UNITED STATES PATENT AND TRADEMARK OFFICE

10/667,181

Office Action Summary	Application No. 10/667,181	Applicant(s) HIGHTOWER, ROBERT C.	
	Examiner Janet M. Wilkens	Art Unit 3637

Fig.9

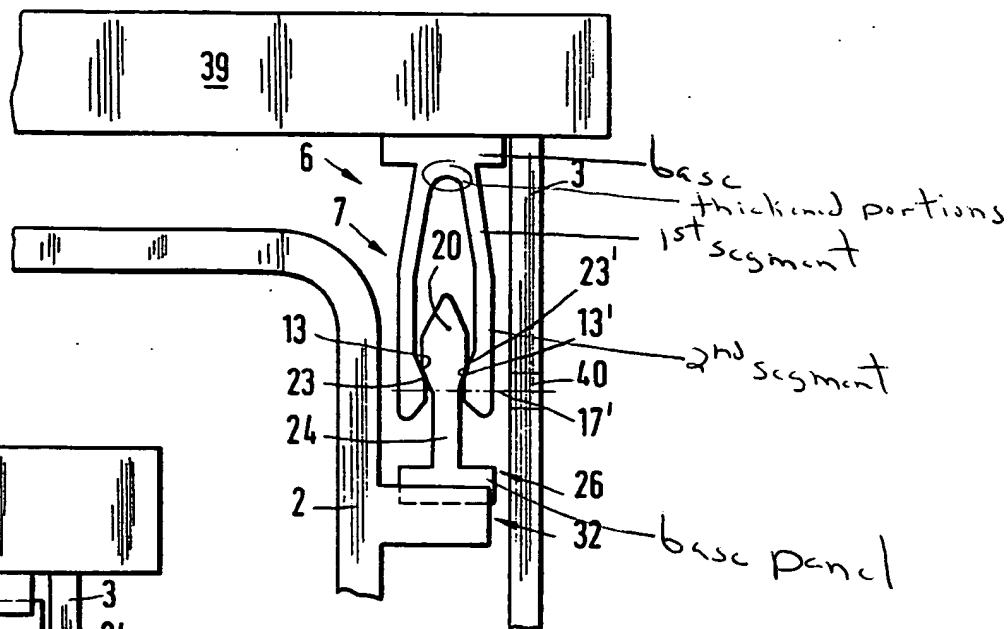
Claims 1, 2, 7-14 16, 18, 19, 32-34 and 37 are rejected under 35 U.S.C. 102(b) as being anticipated by Dupree. Dupree teaches a front panel (39) attached over an opening in an object/drawer/frame (Fig. 9; which is part of a cabinet/housing; see also Attachment A). The panel includes a plastic clip piece (7) having a base and a snap clip with opposed arms extending from the base. The arms each include first and second segments. The first segment of each arm defines an obtuse angle with respect to the base. The object includes a plastic post piece (20,24) received in the clip; the piece includes a base panel and non-circular /diamond posts (20). Furthermore, as best understood, the first segments are thickened adjacent their connections to the base (see Attachment A). Finally, both pieces include apertures (17,27) configured to

receive fasteners. Note: the claims are in "comprising" format; therefore, the cabinet can encompass features not specifically claimed, such as the panels/framing of the cabinet itself. Since the drawer of Dupree is part of a housing/cabinet and meets the structural limitations found in the body of the claims, the "cabinet" preamble portion is inherently met.
